WP10	LPSC	19E
16/12/16		1/39

**Surface Detector Electronics Upgrade
List of ECR**

Abstract:
This document is the list of the UUB ECR defined before, during and after the AE set up.

6.2 Slow-control ESD protection and Temperature sensor power supply modification (WP4 & 5):

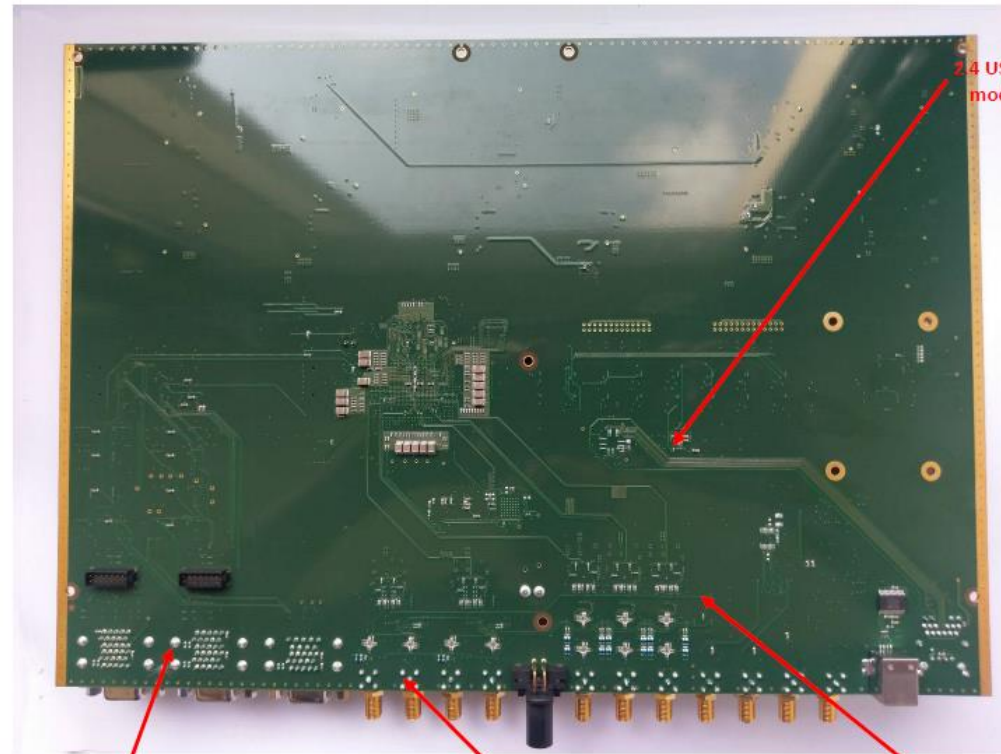
5.4 Type 3, input impedance modifications:

5.3 Vref modifications:

2.4 USB interface modification:

ECR 5-3, Jitter Cleaner replacement by Fanout:

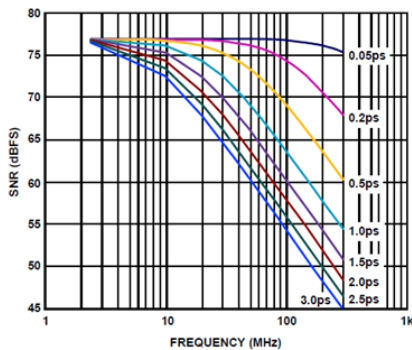
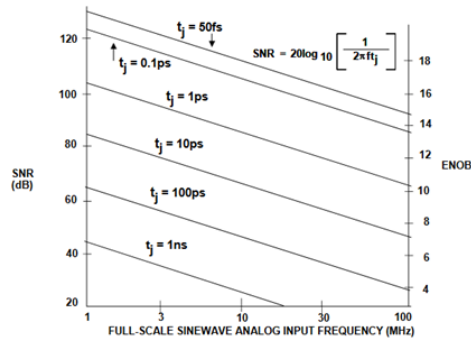
WHAT DO WE NEED: Acceptable SNR (noise) MUST BE define before the choice. MORE JITTER = MORE NOISE

Lower power consumption OR Lower noise

To remove Jitter cleaner -> risk of increase of noise

5.3	Replace Jitter cleaner with fan-out and new VXO to go to 1ps jitter, 3.3V on DAC	- Save power (Layout modifications mandatory)	YES	<input type="checkbox"/> YES <input checked="" type="checkbox"/> NO	<input checked="" type="checkbox"/> YES <input type="checkbox"/> NO
	The jitter on ADC clock is estimated to 100 fs (RMS) with the Jitter-Cleaner and 300 fs with a fan out circuit which is fully acceptable from the point of view ADC resolution degradation and SNR. The power consumption decrease from 700 to 252 mW per UUB. There is no initial configuration required. (see Annex)

ECR 5-3, Jitter Cleaner replacement by Fanout: In present UUB

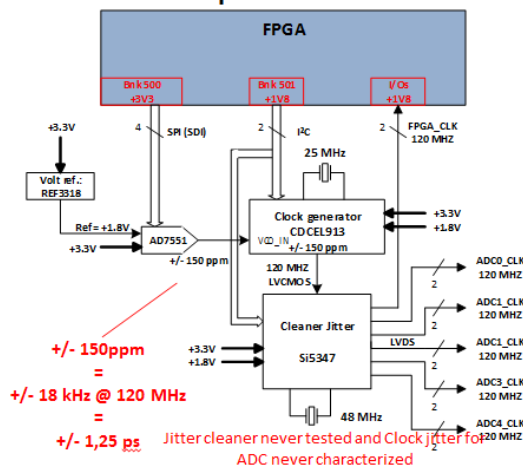
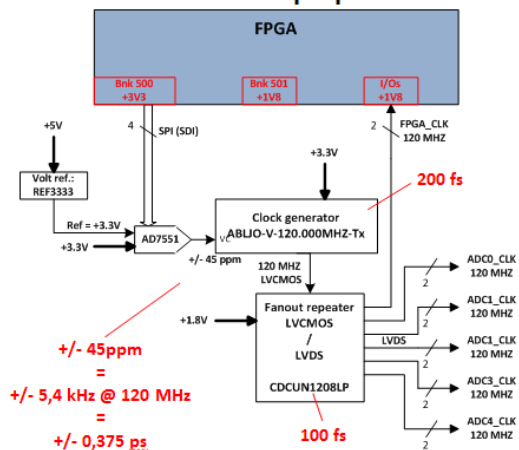
Compliant with ADCs 100fs specs
Clocks Jitter Estimate : 0,1 ps Max
+/- 150 ppm frequency control (+/- 18 kHz)
Configurable
Power: 700mW

Outside ADCs specs.
Clocks Jitter estimate : 0,3 ps RMS
+/- 45 ppm frequency control (+/- 5,4 kHz)
No configuration
Power: 252 mW

ECR 5-16, Optimized ADCs SDIO configuration:

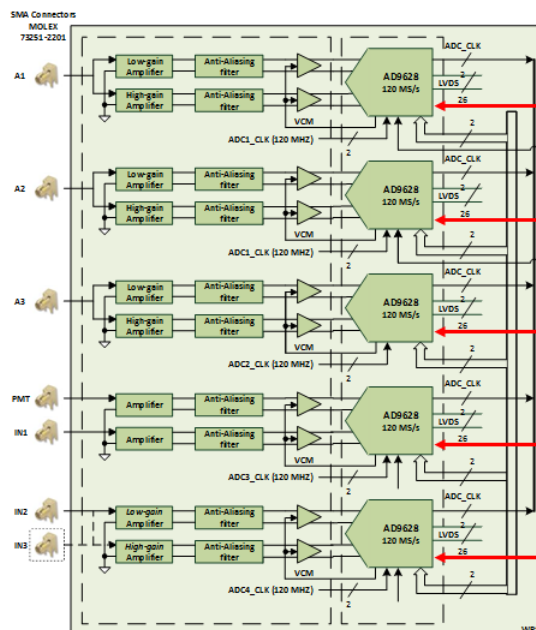
Power_down (1 FPGA pin)

ADCs power down enable from FPGA:

- ADCs initialization.
- Low power when UUB starts.
- Better component's life time.

5.16	Optimized ADCs SDIO Configuration <i>Allow a safe configuration of the ADCs at power up. (see annex)</i>	- Optimization and safety	YES	<input type="checkbox"/> YES <input checked="" type="checkbox"/> NO	<input checked="" type="checkbox"/> YES <input type="checkbox"/> NO

ECR 11.5

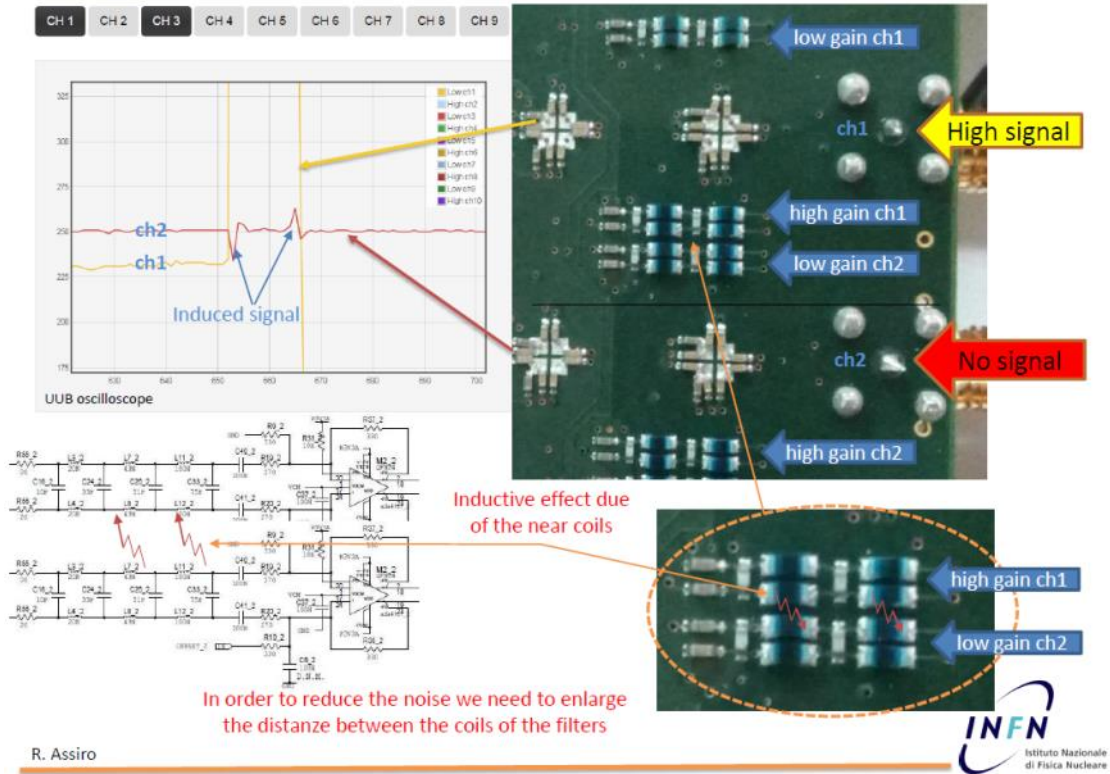
Front-end cross talk

11.5	Filter layout modification	- Reduce inductive cross talk between high gain and low gain next channel.	<input checked="" type="checkbox"/> YES <input type="checkbox"/> NO	<input checked="" type="checkbox"/> YES <input type="checkbox"/> NO
	The filters inductors of each high gain channels are placed too much close to the ones of the next channel low gain. This will generate inductive cross talk between channels. These components should be placed at a bigger distance from each other or on other side of the PCB alternatively. (see annex).

ECR 12.2

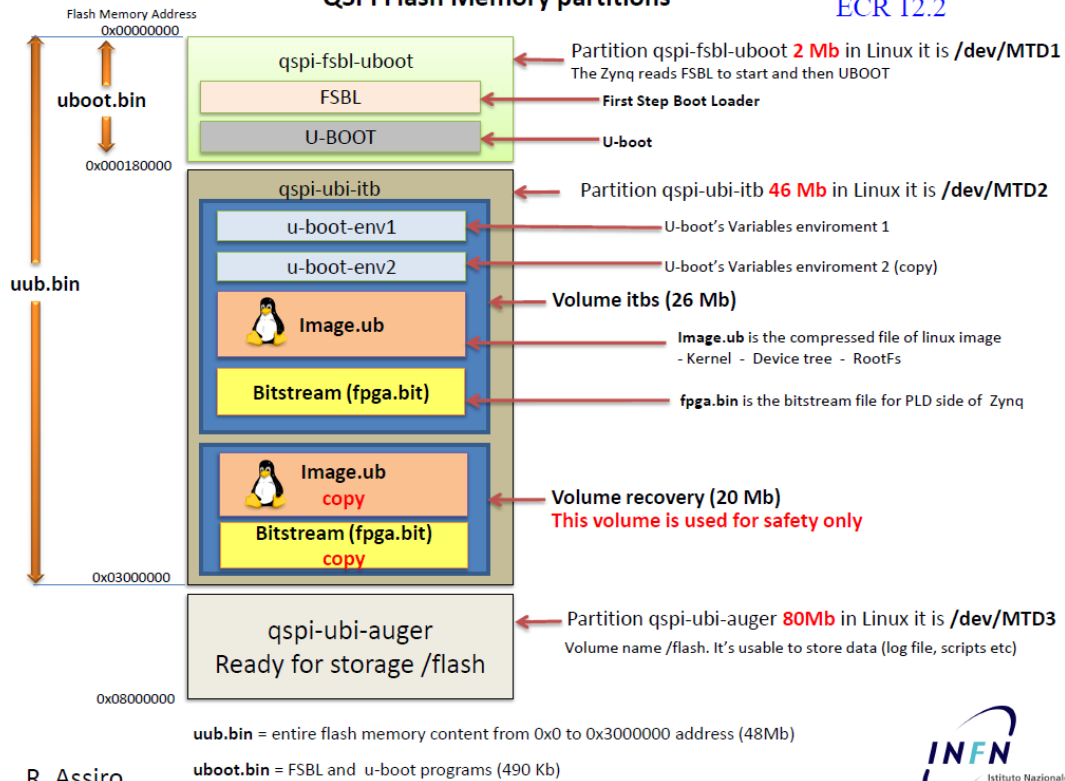
QSPI Flash Memory partitions

12.2	Change the flash memory mapping (see annex)	- Optimization - Maintenance simplification	<input checked="" type="checkbox"/> YES <input type="checkbox"/> NO	<input checked="" type="checkbox"/> YES <input type="checkbox"/> NO

ECR 12.5

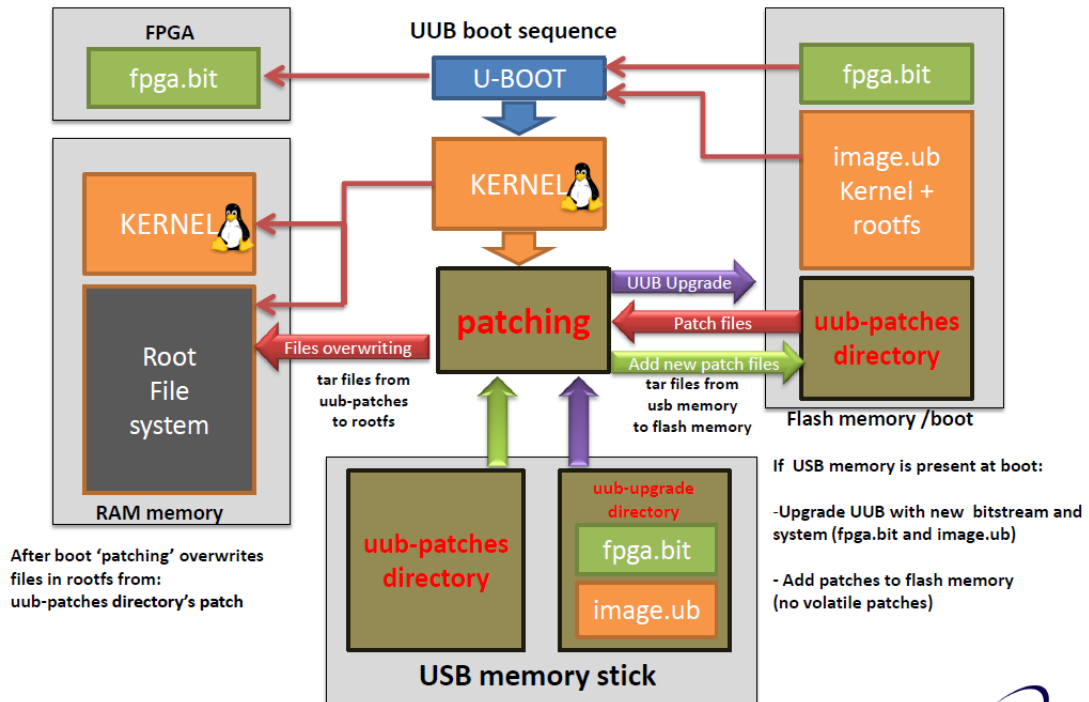
How patching works

12.5	Implement new patching procedure for S/W (see annex)	- Optimization - Maintenance simplification	<input checked="" type="checkbox"/> YES <input type="checkbox"/> NO	<input checked="" type="checkbox"/> YES <input type="checkbox"/> NO

ECRs Slow Control (WP4) ECR 14.2

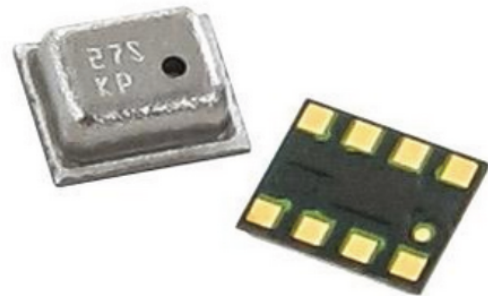
Pressure Sensor BMP180 discontinued

- BMP180 -> BMP280
- Different footprint
- Different Software
- Price 1.39 € @1000

Alternative BME280

- Additional humidity Sensor
- Price 4.59 @ 1000

14.2	Replace on board temperature sensor BMP 180 with ref: BME280 (with additional humidity sensor) This require S/W modification. (see annex)	- Component obsolete	<input checked="" type="checkbox"/> YES <input type="checkbox"/> NO	<input checked="" type="checkbox"/> YES <input type="checkbox"/> NO

ECRs 14.4, 14.9 & 14.10, Resets specifications:

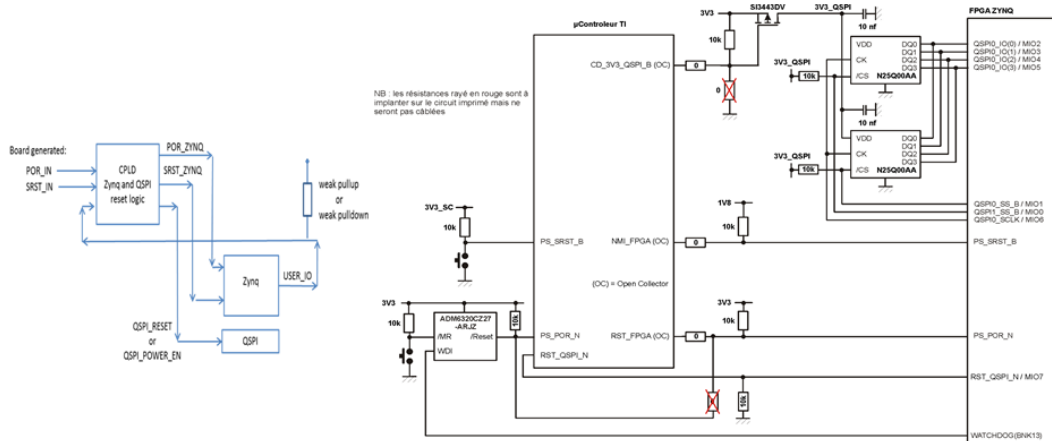
Never clearly specified:

- Watchdog: Reset UUB (FPGA+SC) or only FPGA?
- "Radio" Reset: UUB (FPGA+SC) or only FPGA?

14.4	Change Watchdog logic (H/W and/or S/W) See 5.2, 14.8, 14.9	NCR	<input checked="" type="checkbox"/> YES <input type="checkbox"/> NO	<input checked="" type="checkbox"/> YES <input type="checkbox"/> NO
	There is proposition (from WP1, WP4 and WP5) to re design the Watchdog and reset circuitry learning from the results of the EA. This conduct to integrate part of the logic into the FPGA firmware. A merged and optimized solution should be proposed to be implemented for the next design. (see annex)

Watchdog circuit solution 1

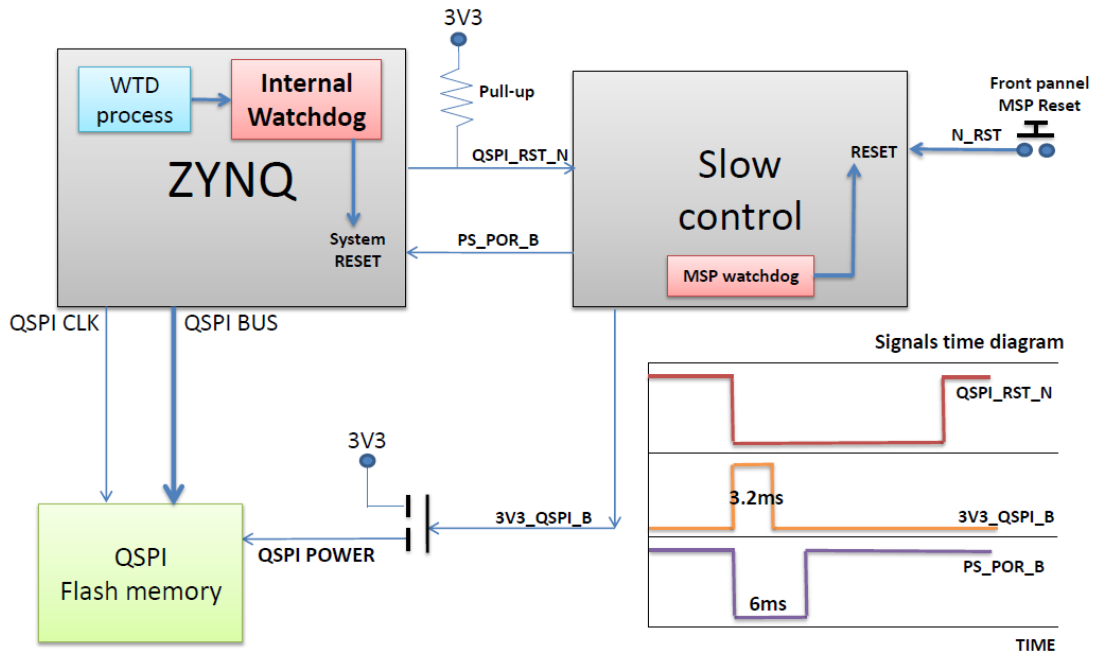
ECR 14.4

Watchdog circuit solution 2

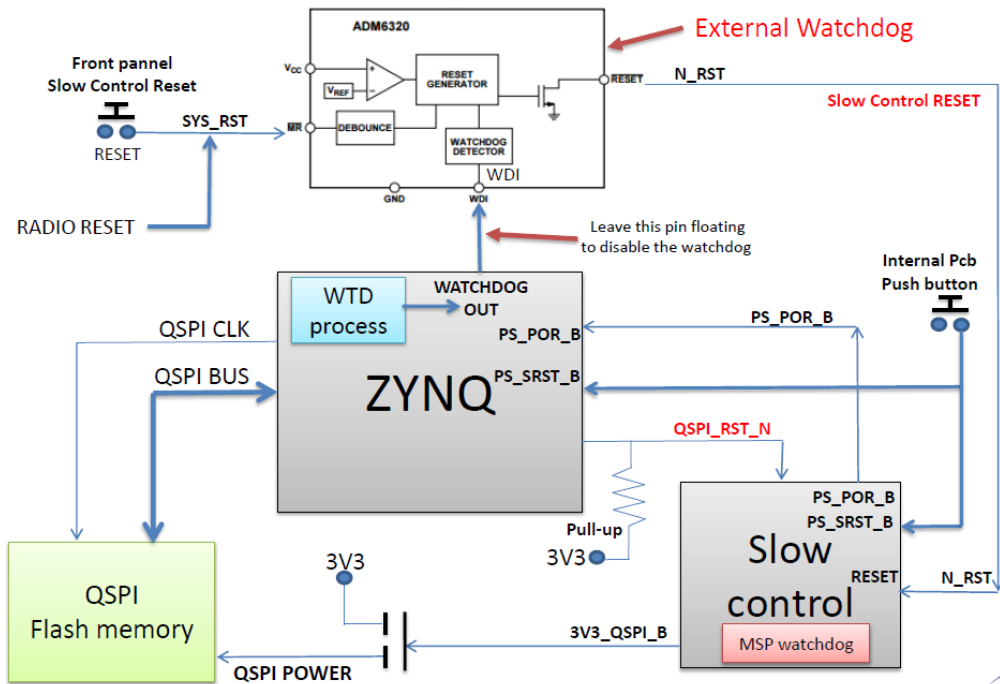
ECR 14.4

ECR 14.8, Solar power system Slow-control management:

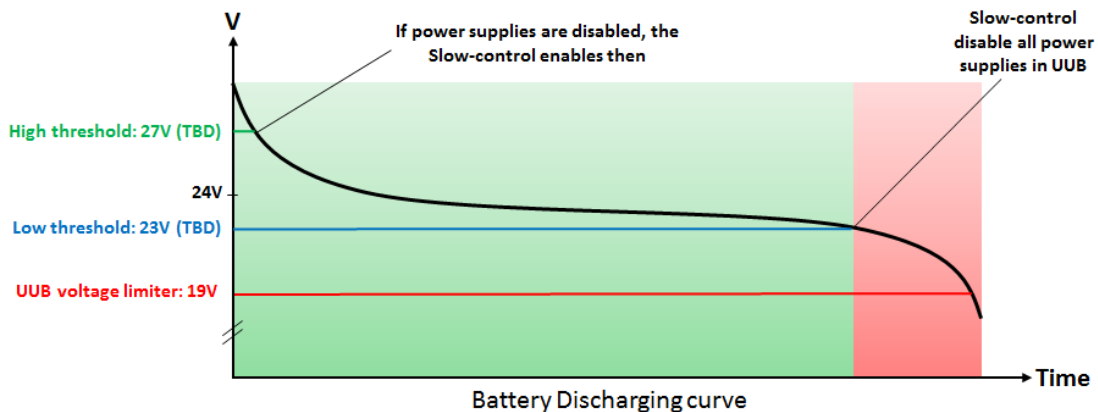
If the battery voltage is too low, the electronic will twinkle. Could damage electronic and battery.

No hardware modification, only Slow-control software.

14.8	Add Failure Detection (FDIR) actions related to Power management into the SC software.	- Battery protection	<input checked="" type="checkbox"/> YES <input type="checkbox"/> NO	<input checked="" type="checkbox"/> YES <input type="checkbox"/> NO
	The idea is to detect the batteries lower voltage limit form the Slow Control voltage measurement and to raise an alarm toward the Monitoring and then take the action of switching off all the powers supplies (SC excepted). Same mechanism can be applied in case of over-voltage. (see annex)

ECR 15-1, -3,3V DC/DC to be changed :

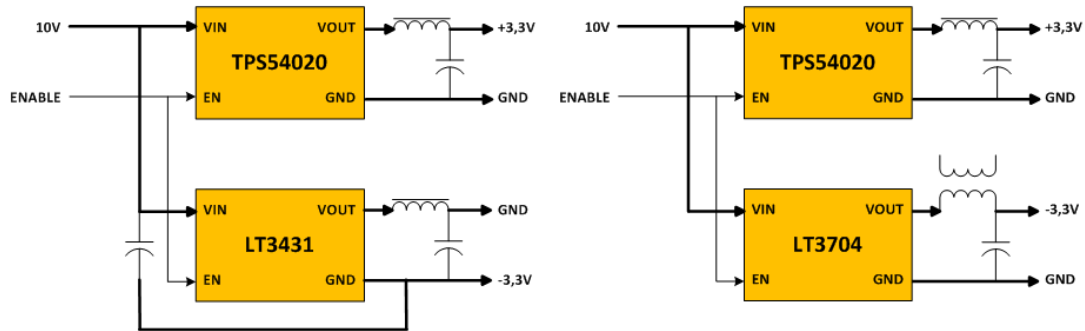
Charge pump technology
-3,3V is DC/DC voltage reference
-3,3V Enable, ERC 1-15(Feb 2016)

Not Charge pump technology: less noisy
"Enable" NCR suppressed

Positive voltage -> negative voltage, noisy and low efficiency

#	WP5 Modification	Motivation	Accepted ?	To be implemented on the new design ?
15.1	Replace -3,3V LT3431 DC/DC converter <i>Replaced with ref: LT3704 with no charge pump technology: less noisy (see annex)</i>	- ECR #1.5 (-3.3V enable, NCR 2-40) - Conducted noise reduction	<input checked="" type="checkbox"/> YES <input type="checkbox"/> NO	<input checked="" type="checkbox"/> YES <input type="checkbox"/> NO

ECR 15.12, Change Power supply connector position:

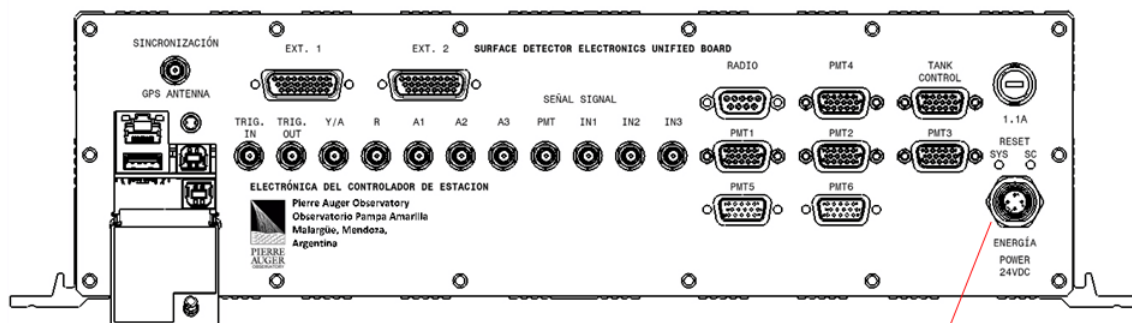
Away from Front-end area on PCB to lower the noise
(actual position -> specification request).

Power supply
connector and fuse

15.12	Move position of the main power connector (and fuse) on the right side of the board (from the front view of the front panel) <i>Compliant with the existing cable length. (see annex)</i>	- Reduce conducted noise from outside (shorter cable) and inside (power wires far from analog area)	<input checked="" type="checkbox"/> YES <input type="checkbox"/> NO	<input checked="" type="checkbox"/> YES <input type="checkbox"/> NO

ECR 15.24, Start problem Slow-control micro-controller:

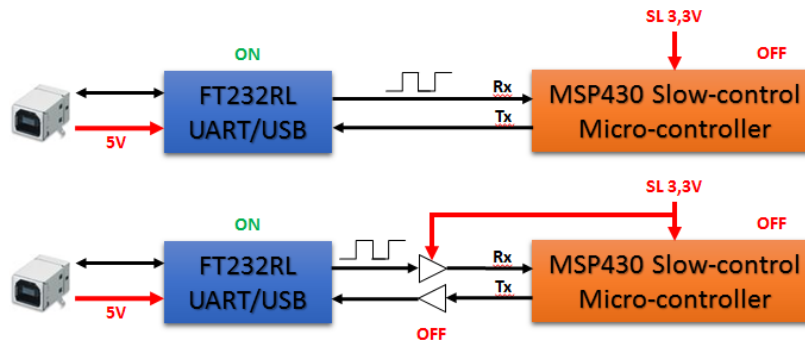
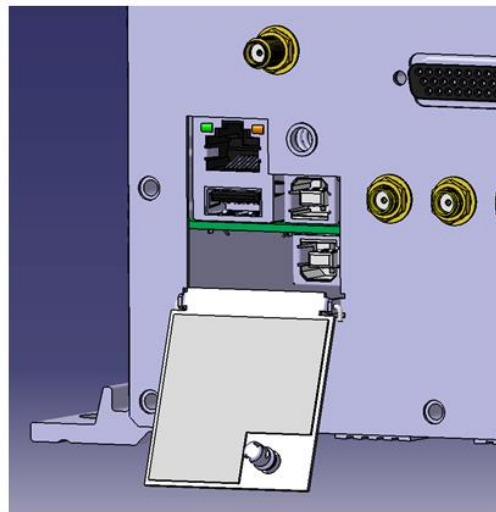
Sometime, the micro-control stopes during start sequence (NCR n° 2-67). Only when a PC is connected before the UUB turn ON.

This must be made also for FPGA UART.

15.24	Add buffers on RX/TX line for USB Slow Control connection. <i>Also on the FPGA UART (see annex)</i>	- NCR - To solve start-up failures on the MSP430	<input checked="" type="checkbox"/> YES <input type="checkbox"/> NO	<input checked="" type="checkbox"/> YES <input type="checkbox"/> NO

ECR 15.4 & 15.27, Optimized all DC/DC layout 1/2:

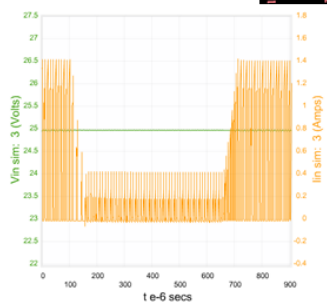
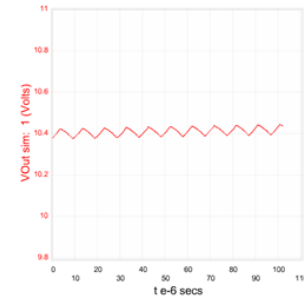
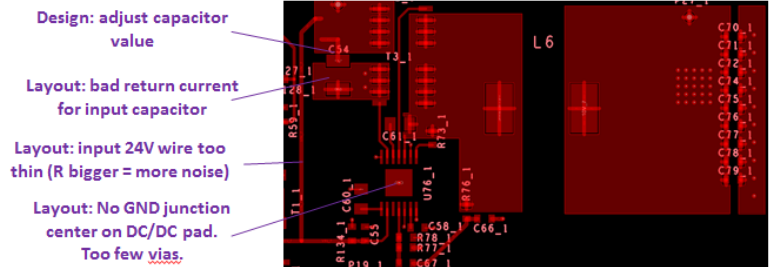
Change present 10V DC/DC LMR3150?

LMR3150, The best performances

15.4	Optimize all DC/DC converter layout and grounding. (see annex)	- Layout NCR - Conducted noise reduction	<input checked="" type="checkbox"/> YES <input type="checkbox"/> NO	<input checked="" type="checkbox"/> YES <input type="checkbox"/> NO

#	WP5 Modification	Motivation	Accepted ?	To be implemented on the new design ?
15.27	Replace 10 V DC/DC converter	- Reduce conducted noise	<input type="checkbox"/> YES <input checked="" type="checkbox"/> NO	<input type="checkbox"/> YES <input checked="" type="checkbox"/> NO
	The actual 10V DC/DC converter (LMR3150) has very good performances in terms of noise, efficiency, protection and transient response. The decision is to keep this component and to improve the layout for an optimized grounding, and the filtering with values more adapted to the UUB behavior than the data sheet standard configuration. (see annex)
